NOTICE TO CONTRACTOR

APPROVED

McKee Homes, LLC
Lot 1019 Anderson Creek Carriage Glen
Torino II Craftsman
RH Monoslab Foundation

REAR ELEVATION W/ OPT. COVERED PORCH
 1/4" = 1'-0" AT 22'X34" LAYOUT 1/8" = 1'-0" AT 11" X 17" LAYOUT

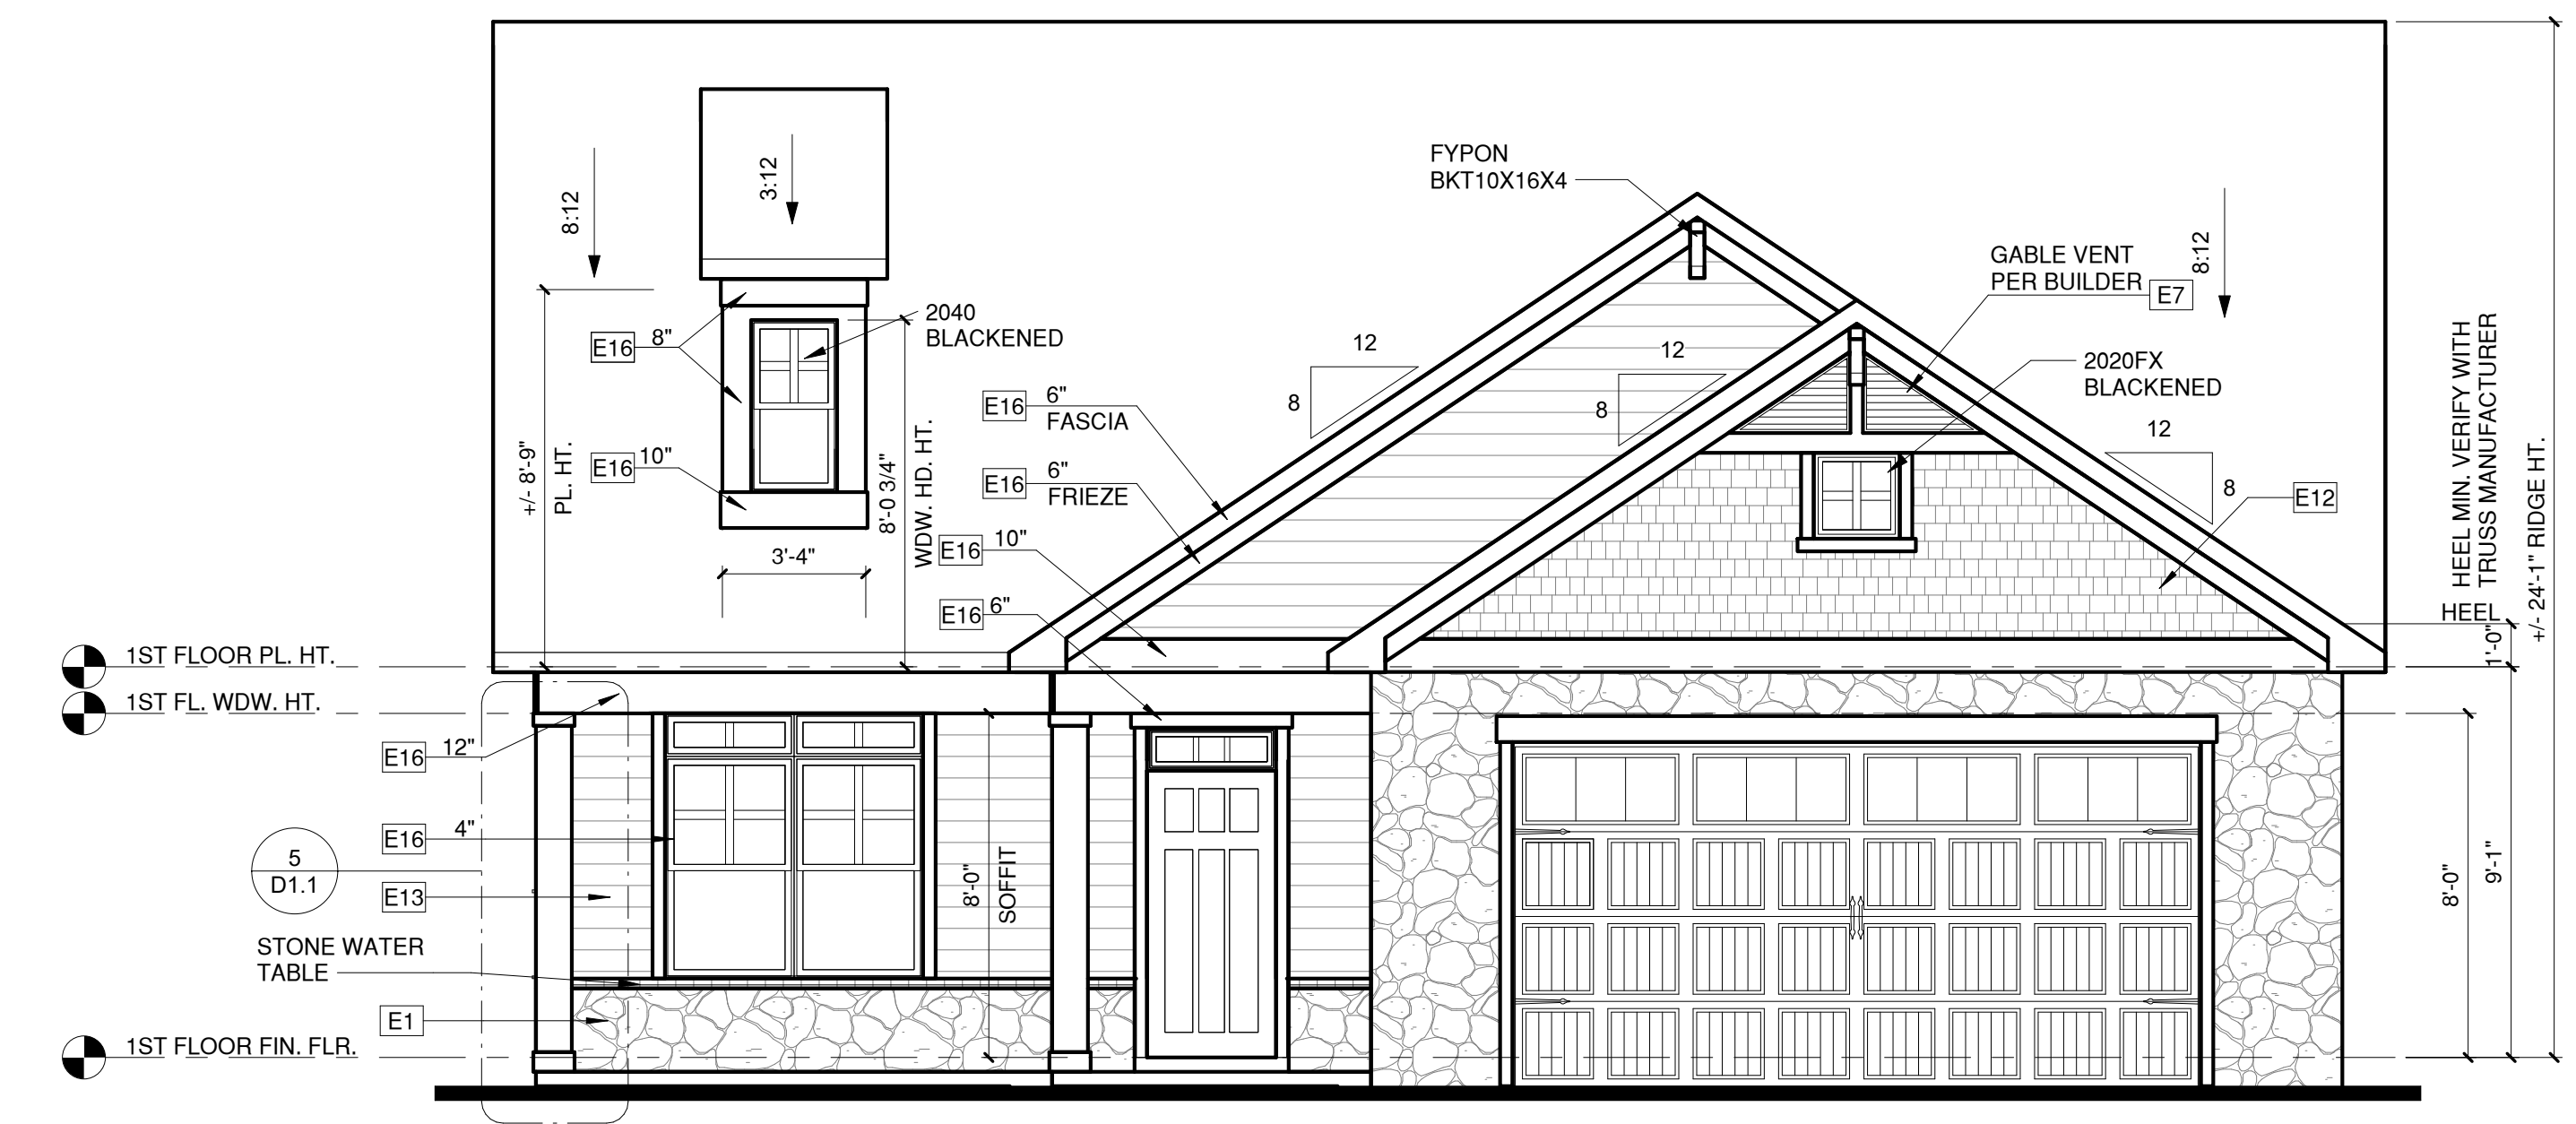
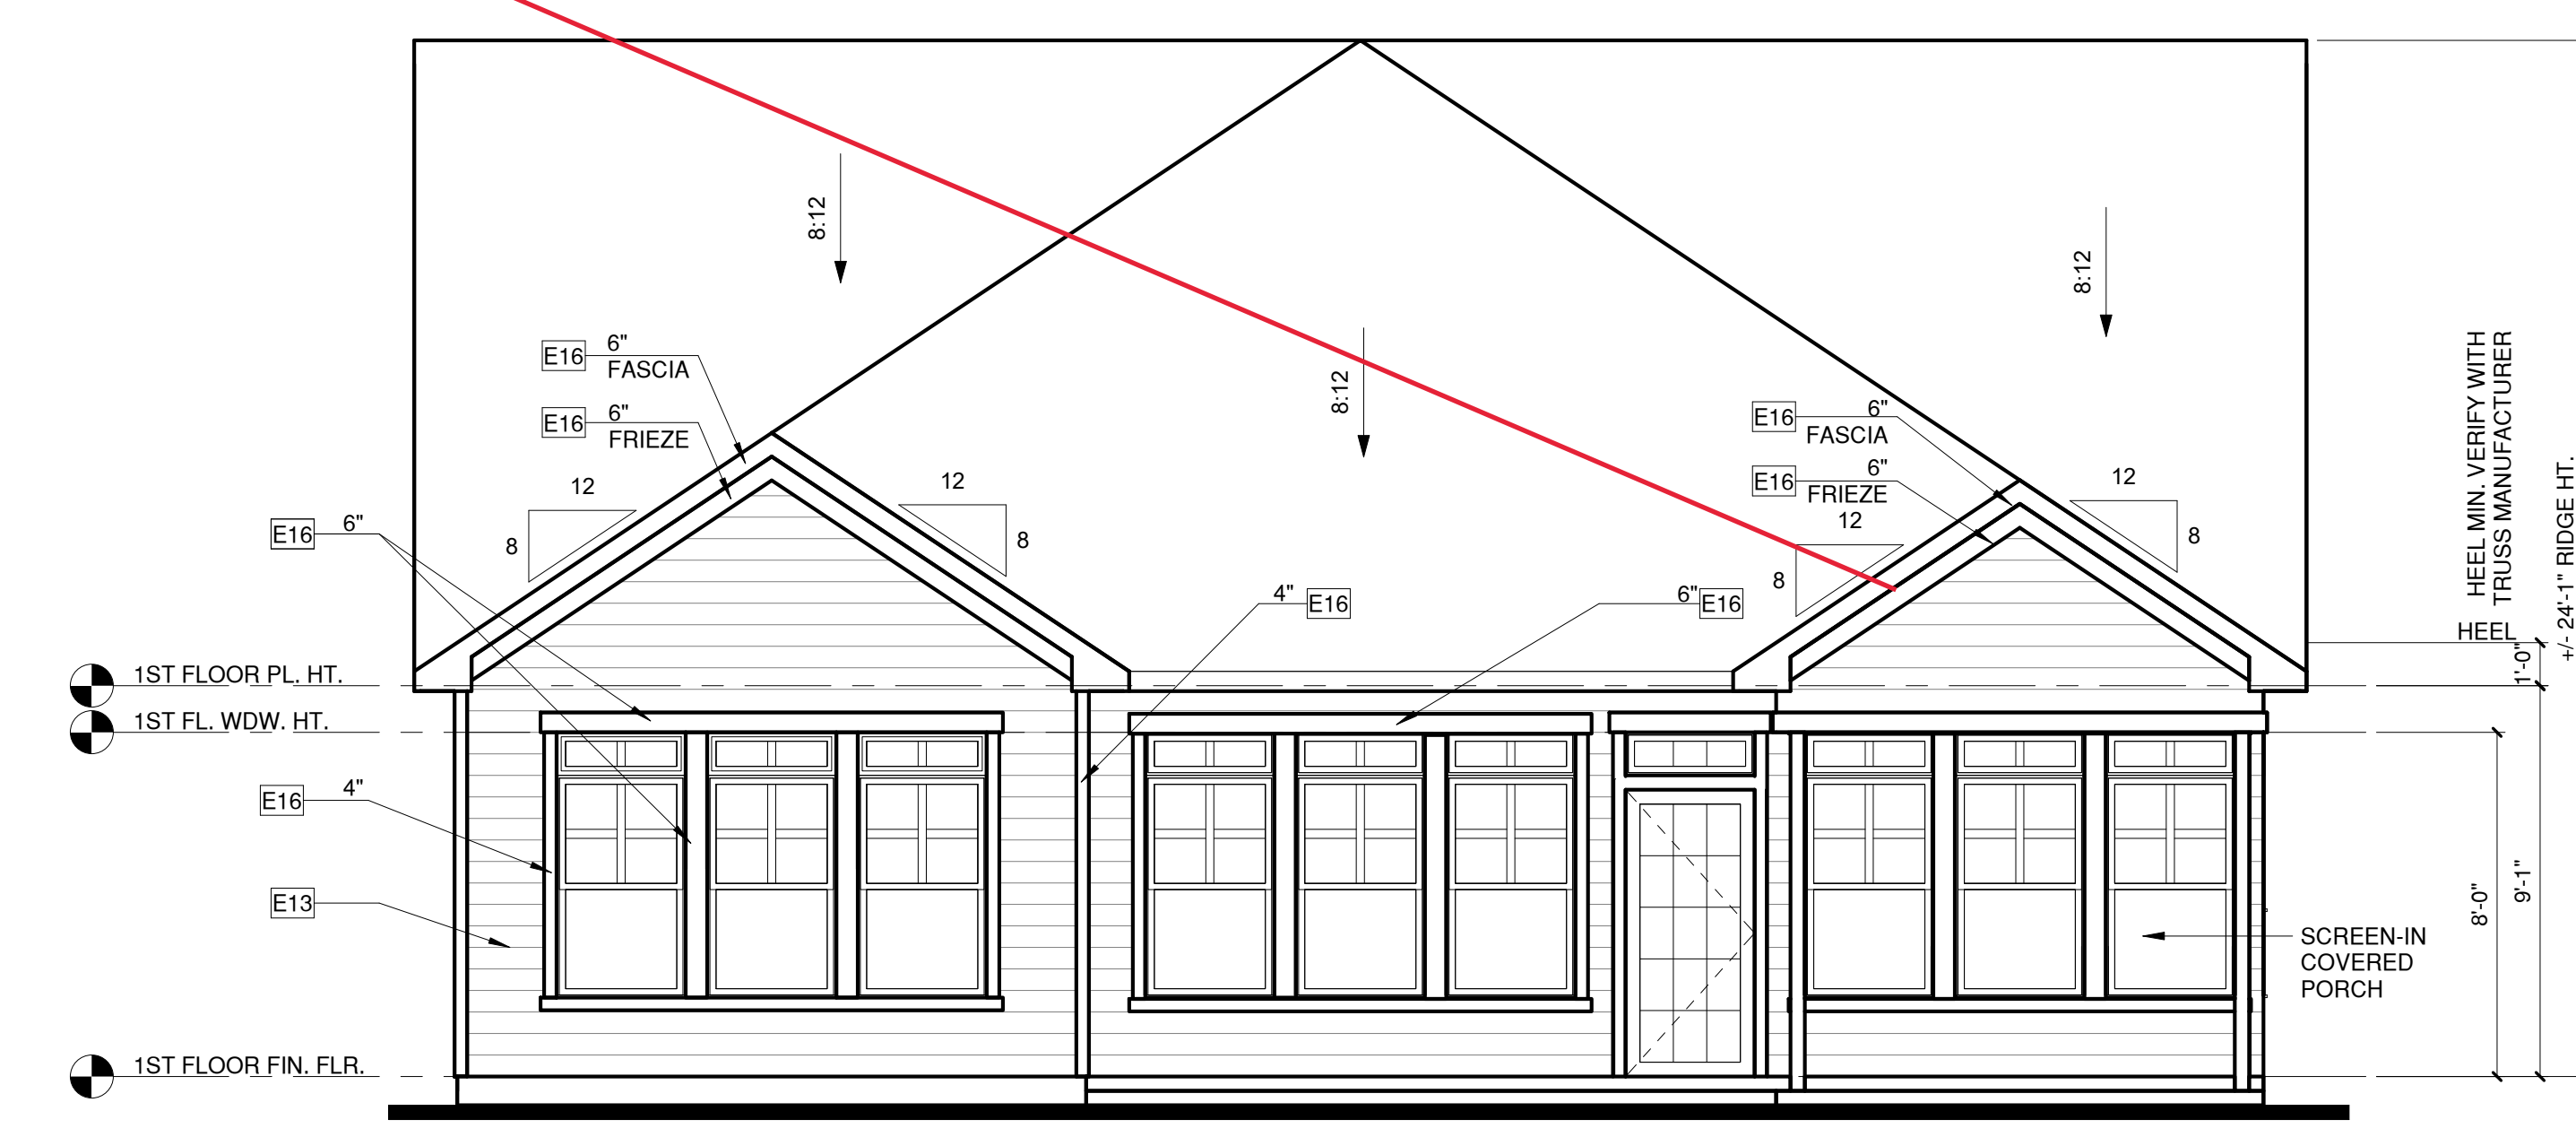
USE THIS COVERED PORCH ELEVATION

RIGHT ELEVATION W/ OPT. COVERED PORCH

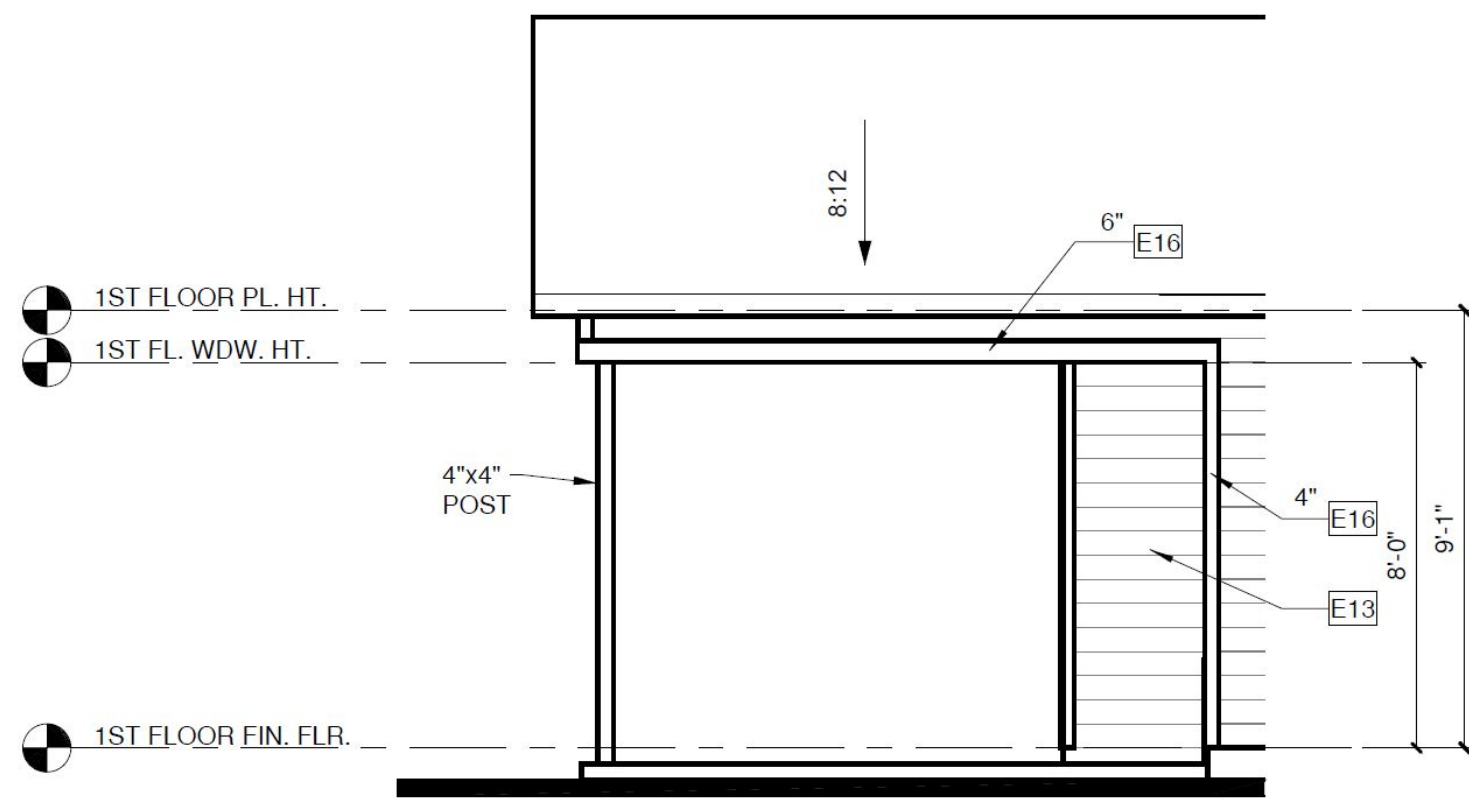
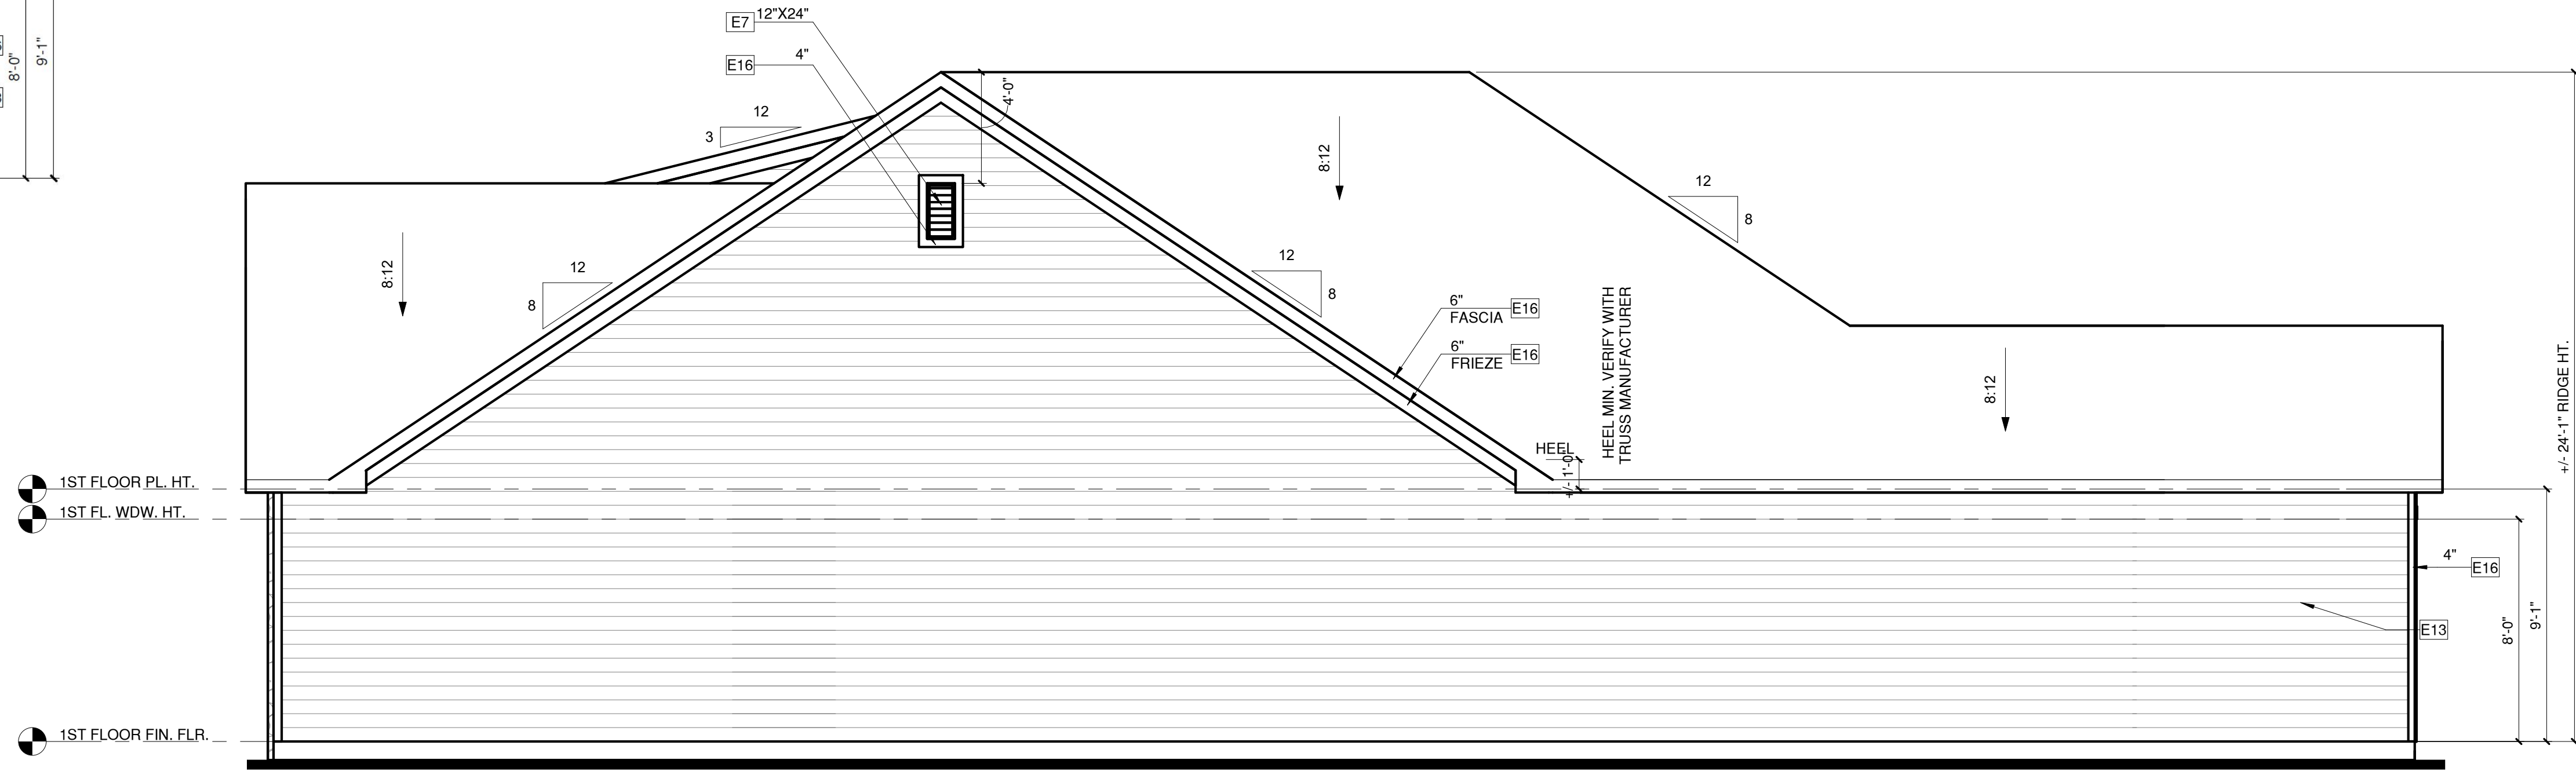
USE THIS COVERED PORCH (RIDGE IS HIGHER)
